A REVIEW OF THE DIABLO CANYON POWER PLANT DIESEL GENERATOR ALLOWED OUTAGE TIME STUDY

September 1989

Risk Evaluation Group Department of Nuclear Energy Brookhaven National Laboratory Upton, NY 11973

Prepared for
U.S. Nuclear Regulatory Commission
Washington, DC 20555
Contract No. DE-AC02-76CH00016
FIN A-3958

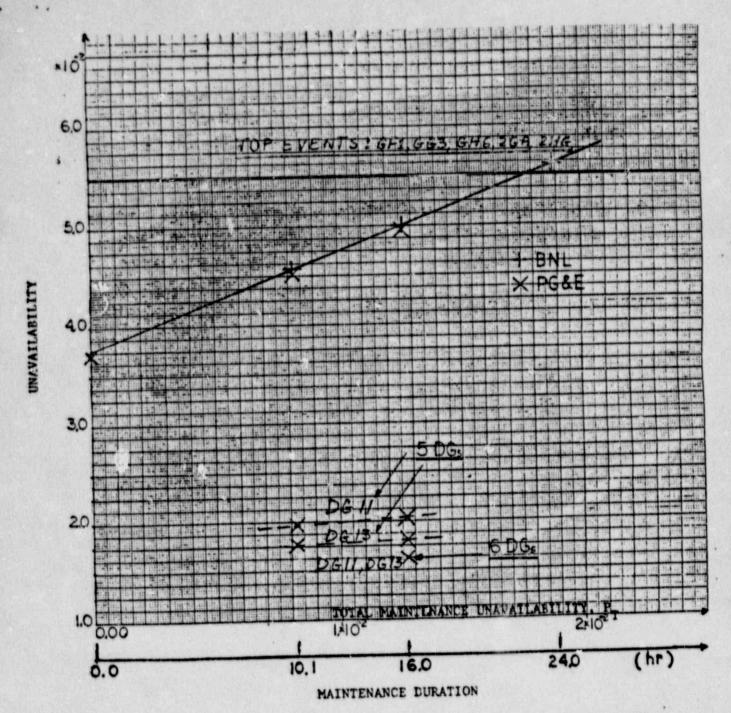
In order to check the internal consistency of the results obtained, the various split fractions can be plotted against the Total Maintenance Unavailability, P_T . This functional representation is convenient because it allows us to interpret the results when one considers a mean diesel maintenance frequency other than the 7.74-4 hr⁻¹ offered by PG&E.

Figure 2.1 shows such a functional representation for the non-seismic top event split fractions GF1, GG3, GH6, 2GA, 2HG. The graph of these split fractions appears to be a straight line. Its extrapolation to $P_T = 0$ provides a quite accurate graphical checking of the corresponding PG&E value given for "Zero Diesel Maintenance" calculations in Table 4.3 of the AOT study. (Similar "graphical" spot checking "validated" other "zero maintenance" split fractions as well.)

The split fractions shown in Figure 2.1 essentially represent the unavailability of the individual diesel units in the DCPRJ, when all the support systems are available (see Part II).

For comparison, the unavailabilities of DG11 and DG13 determined by the "more detailed" reliability analysis calculations are also plotted as a function of the maintenance duration. Its not clear why the PRA unavailabilities are larger (about a factor of 2) than those obtained with the reliability model, where the support system unavailabilities were not taken to be zero.²

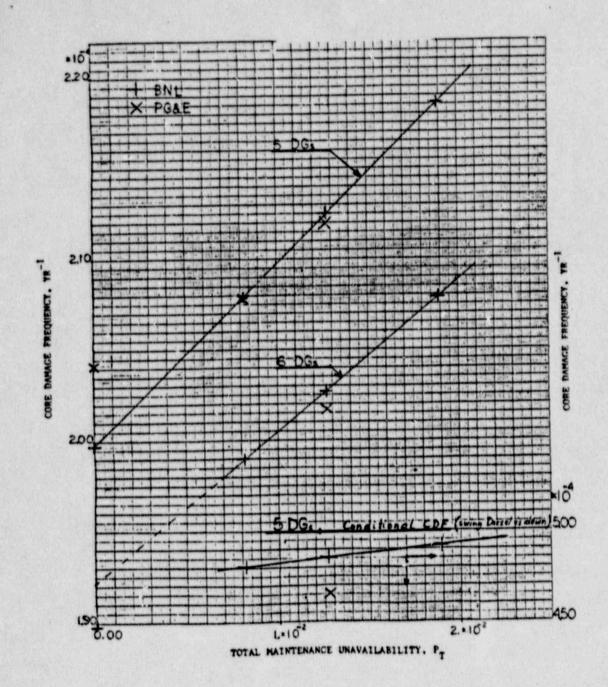
Figure 3.1 shows the core damage frequency as a function of the total maintenance unavailability, F₁ for the 5DG and 6DG configurations. One can observe that the functional correlation between the CDF and the total maintenance unavailability can be fairly approximated by straight lines. The lines for 5DG and 6DG configurations run (almost) parallel, showing that under any reasonable AOT condition the 6DG configuration always provides smaller risk than the 5DG configuration.

The results obtained from the above calculations are also listed in Table 3.1 along with the original PG&E data. The conditional core damage frequency if the swing diesel is down for a year (5DG configuration) is also plotted as a function of the total maintenance unavailability, P_T, at the bottom part of Figure 3.1. The curve reflects a strong linear dependency.

- The risk reduction effect of a adding the sixth DC is greater than the
 effect of changing to a seven day AOT. This is demonstrated by Figure
 3.1, which shows that the CDF curve for the 6DG configuration always
 runs below and almost parallel with the CDF curve for 5 DG
 configuration.
- The effect on risk of changing from a three day to a seven day AOT is insignificant, on the order of 2 to 3%. (The curves in Figure 3.1 provide practical tools to evaluate risk changes for any combinations of diesel maintenance duration and frequency values.)
- The increase of the risk associated with a seven day AOT over a three day AOT performing scheduled maintenance on the swing diesel is also insignificant; less than 2.8%. The risk racios determined by PG&E for this case are in agreement with those obtained by BNL for both 5DG and 6DG configurations.
